**Oregon State University Application for Special Nuclear Material License
Request for Additional Information**

Revised Application (Redacted)

APPLICATION FOR LICENSE
OF
SPECIAL NUCLEAR MATERIAL

Figure A3.1: Element Storage Cabinet

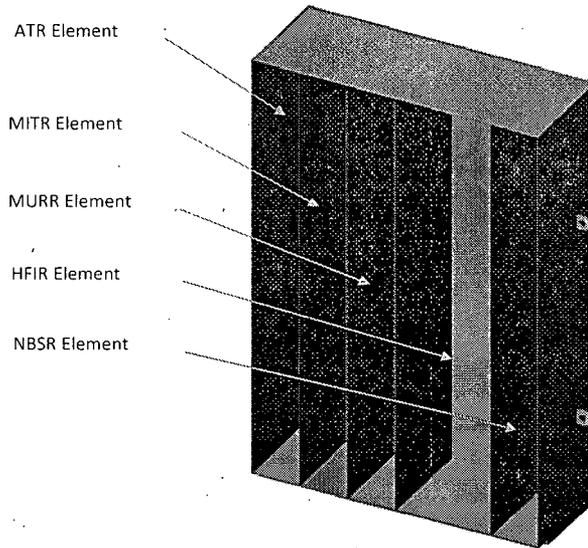
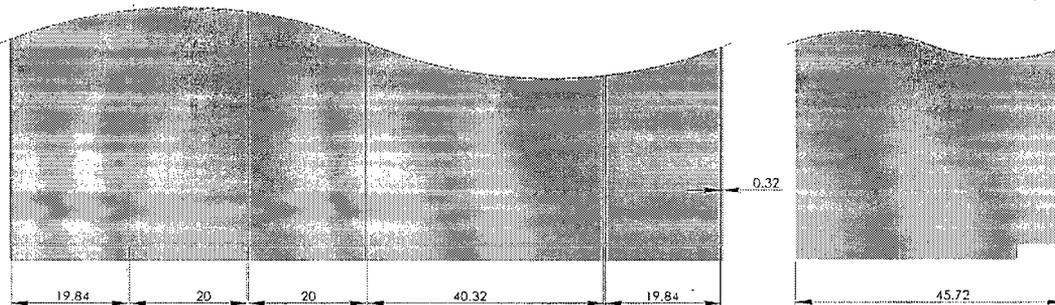
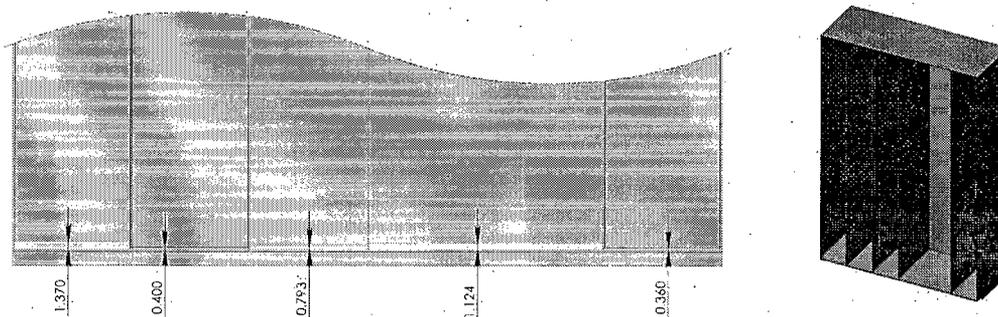
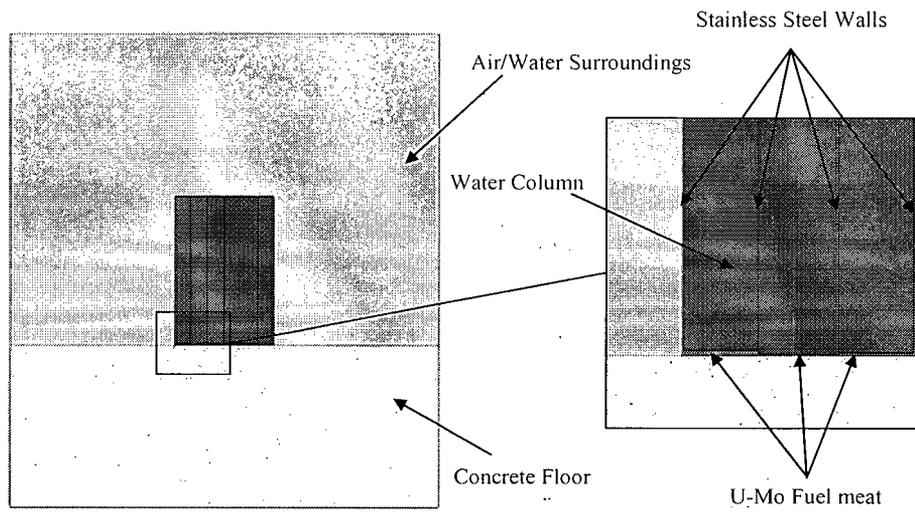
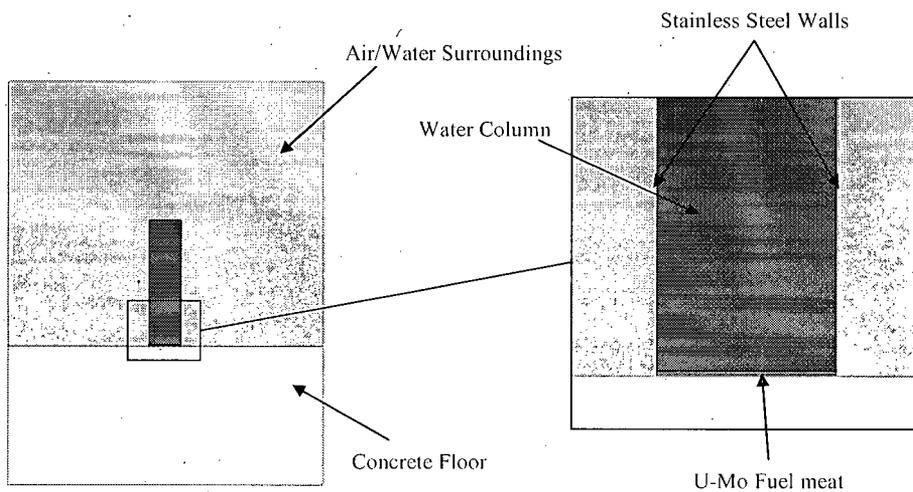
What is the criticality level of the material in the event of a fire where all of the material melted together and water was added?

Let us assume that the most credible and limiting off-normal scenario associated with the oversight of the materials to be a fire which consumes the fuel elements such that the surrounding temperature exceeds their melting point temperature allowing for their reconfiguration.

A lock out/tag out procedure will allow for only single element to be removed from the storage cabinet at any given time. As a result of this administrative requirement, it is then assumed that the most limiting criticality scenario during a fire will occur if all elements are stored in their designated locations within the storage cabinet. The limited geometry of the cabinet will not allow for the fuel to melt and spread across the floor of the facility, but rather remain confined in their storage locations in a more favorable geometry. Figure A3.1 presents a rendering of the element storage cabinet.

During this accident scenario it is assumed that fire takes place inside the cabinet melting all fuel meat, while burning all the aluminum cladding away. In order to stop the fire it is assumed that workers spray the cabinet with hoses. At the end of the scenario the cabinet is lined with the accumulative volume of fuel meat at its floor and a column of water above the fuel which fills the cabinet completely as a result of the fire hose. The integral fuel region volume of each element presented as a part of the safety analysis report is summarized in Table A3.1.

An MCNP5 model was built to simulate the previously described scenario. Figure A3.4 and Figure A3.5 present a front and side view of the MCNP5 model. Concrete and air or water surround the farthest

Figure A5.1: Vertical cross-section of the MCNP5 storage configuration model

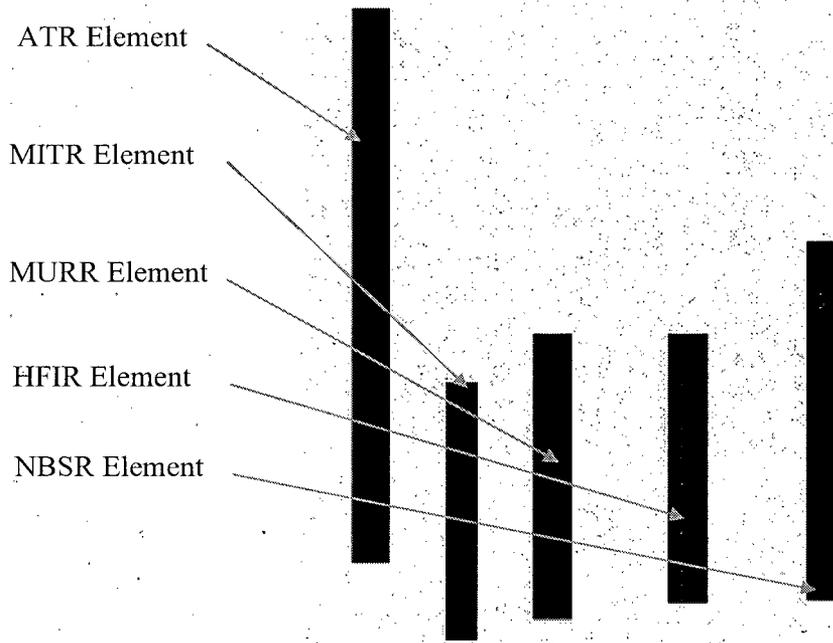
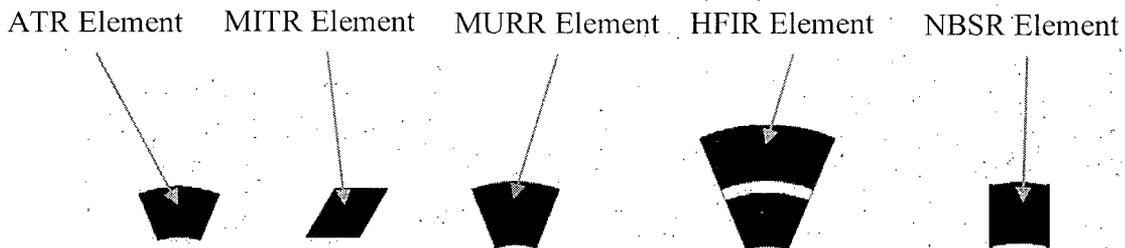
5 RESPONSE TO QUESTION 3

All five elements were modeled and assumed to be in an infinite medium of moderator. The infinite medium was modeled as a cubic volume of moderator material extending beyond the maximum fuel element dimensions by two (2) meters in all directions. This is assumed to be a sufficient attenuation distance such that it is analogous to that of an infinite medium. All elements were modeled using their designated as-built drawings. The elements sit on the floor of the storage cabinet in their storage

A summary of the effective multiplication factors calculated by MCNP5 is presented in Table A5.1. The largest eigenvalue was determined to be that of 100% water with a value of 0.75161 ± 0.00136 .
